**METROPOLITAN GOVERNMENT OF NASHVILLE AND DAVIDSON COUNTY**

**STAFF RECOMMENDATION**  
**1703 Woodland Street**  
**June 20, 2012**

**Application:** New construction—addition  
**District:** Lockeland Springs-East End Neighborhood Conservation Zoning Overlay  
**Council District:** 06  
**Map and Parcel Number:** 08310030000  
**Applicant:** Jeremy Walker, Cathedral Homes  
**Project Lead:** Melissa Baldock, melissa.baldock@nashville.gov

<p><b>Description of Project:</b> Application is to construct a rear addition.</p> <p><b>Recommendation Summary:</b> Staff recommends approval of the application with the following conditions:</p> <ol style="list-style-type: none"> <li>1. The left side of the addition be inset one foot (1') from the back wall of the house.</li> <li>2. A trim board be added to the right side of the house to separate the historic house from the addition.</li> <li>3. Staff review and approve the roof material and color, window and door specifications, and the porch column material prior to purchase and installation.</li> <li>4. A cap and a base be added to the porch columns.</li> </ol> <p>With these conditions, staff finds the project to meet Section II.B. of the

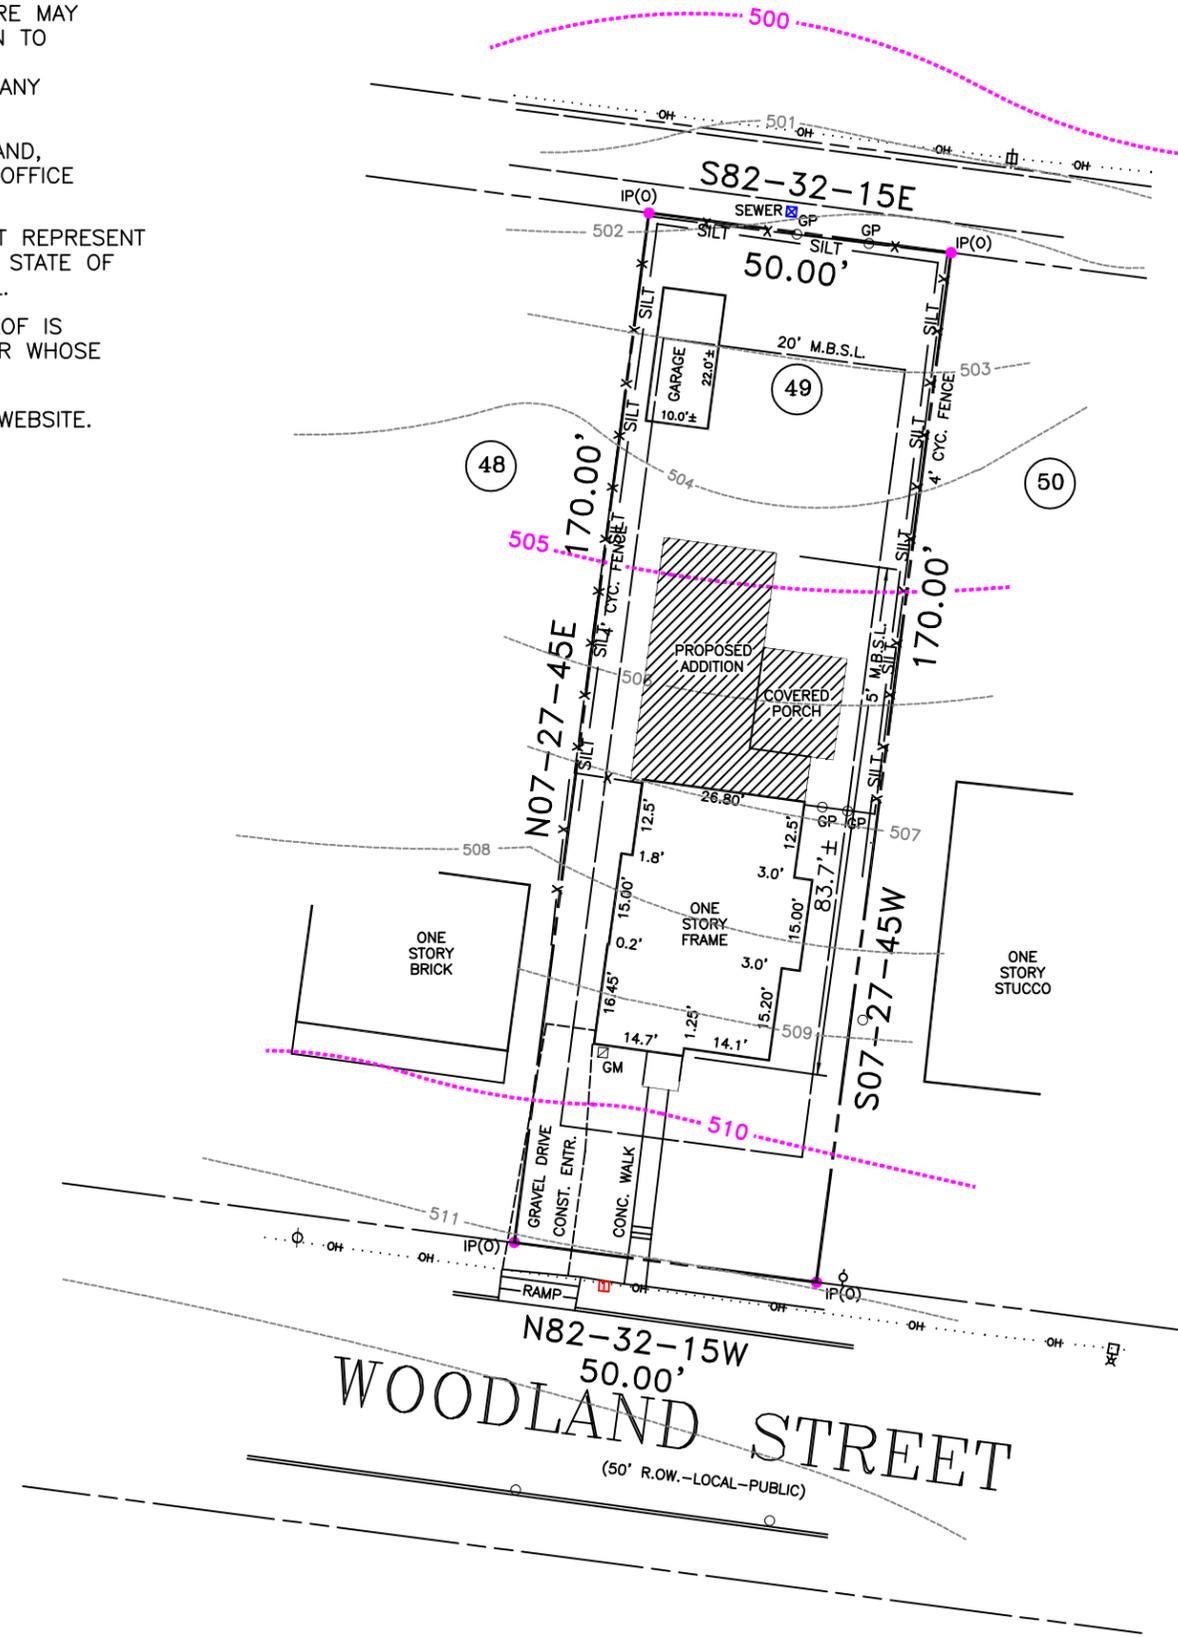
three foot (2'6" X 3') window opening will be removed (see photo below). Staff finds the removal of this window opening appropriate because it is on a wall plane that is inset from the rest of the house, and it is located towards the rear of the historic house. It is at most minimally visible from the street. See photos below.

Window opening to be removed.

The window opening is only minimally visible from the front.

Main Floor  
Scale 1/8" = 1'

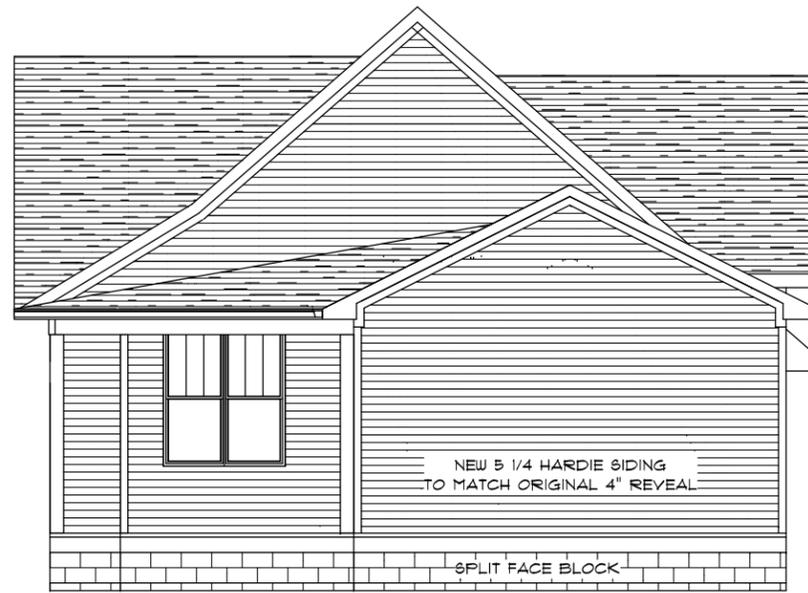
**Location and Setback:** The addition meets all base zoning requirements for setbacks and is no wider than the existing house. On the left side, the addition does not step in from

the rear back wall of the house, but rather steps out from the back wall of the house by approximately one foot, eight inches (1'8"). In other words, this left side of the addition is proposed to line up with the wider portion of the house rather than step in from the inset back portion of the house. Staff asks that a condition of approval be that the addition be inset a minimum of one foot (1') from the back left wall of the house for a length of at least several feet before expanding out to match the full width of the house on this side. See photo below for clarification.

On the right side, the addition lines up with the back wall of the house. Staff finds the lack of an inset appropriate in this instance so long as the left portion of the addition is inset from the back wall of the house and a trim board is added to the right façade to separate visually the old from the new. The roof changes height and pitch at this point, and adding a trim board will further differentiate the existing house from the addition. After eight feet (8') of addition, a screened porch is proposed that will expand out three feet (3') from the wall of the addition to line up with the historic house's widest side wall. See photos below for clarification.

1. The left side of the addition be inset one foot (1') from the back wall of the house.
2. A trim board be added to the right side of the house to separate the historic house from the addition.
3. Staff review and approve the roof material and color, window and door specifications, and the porch column material prior to purchase and installation.
4. A cap and a base be added to the porch columns.
